Technical Service Bulletin: TSB130044

New Fuel Pump Gear Pump with Revised Fuel Line Locations

This document releases new and remanufactured fuel pump gear pumps with revised fuel lines.

Figure 1, Top Port Pump Gear Pump with Revised Fuel Line Locations.

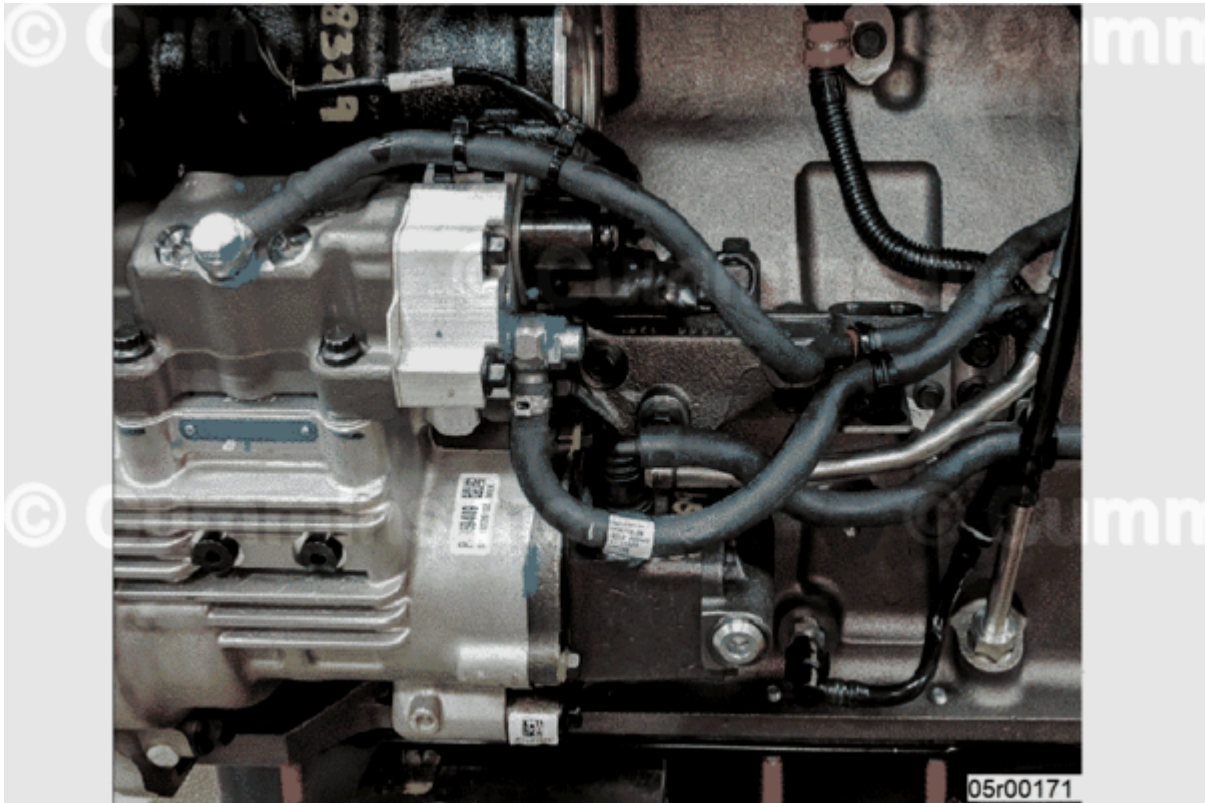
- Engines were released with the fuel lines located on the bottom of the fuel pump gear pump.
- A new design fuel pump gear pump has been released with the fuel line location changed to the top of the fuel pump gear pump. See Figure 1 and 2 below.
- Upgraded fuel lines were released accordingly.

Do not relocate O-ring threaded plugs to top of fuel pump gear pump. Removal of O-ring threaded plugs from fuel pump gear pump assembly will result in external fuel leaks.

Figure 3, Remanufactured Fuel Pump Gear Pump with Plugged Bottom Ports.

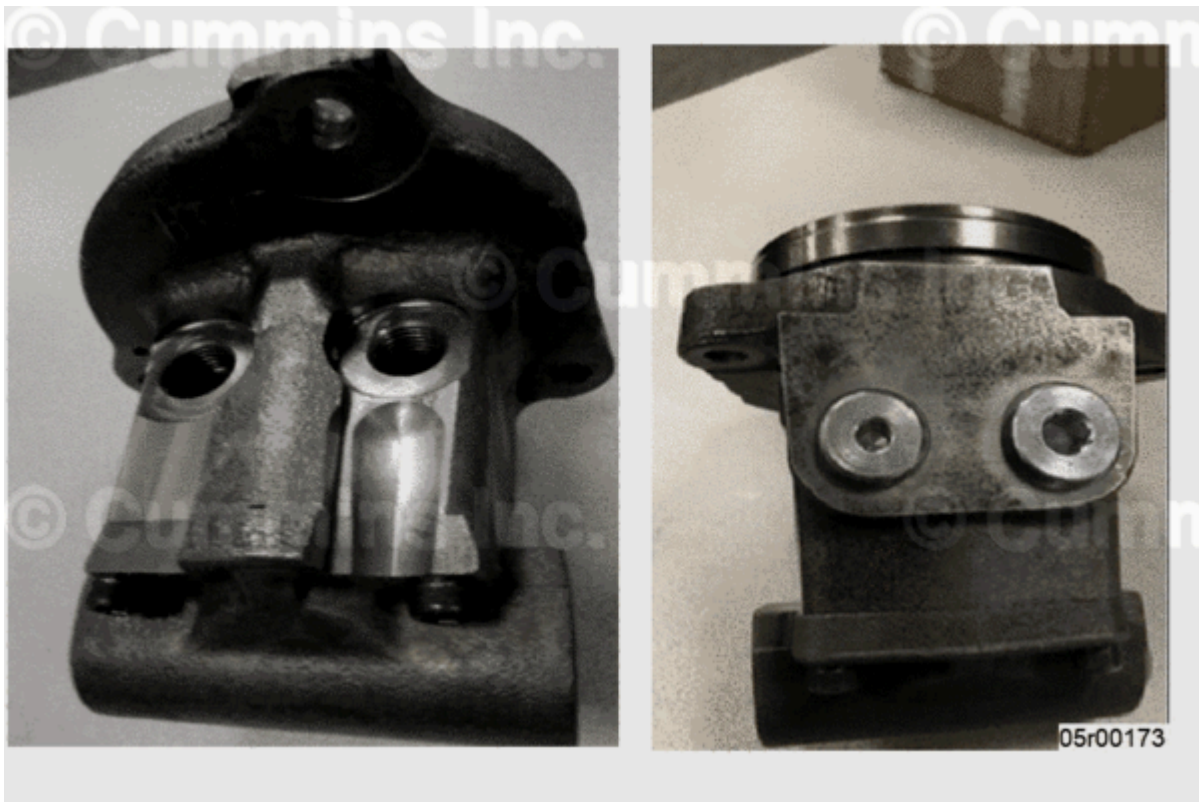
- Fuel pump gear pumps with original bottom fuel line ports have been remanufactured to introduce an upper fitting location; required for top fuel supply tube plumbing. The bottom ports on the fuel pump gear pump have been plugged. See Figure 3 for visual representation.
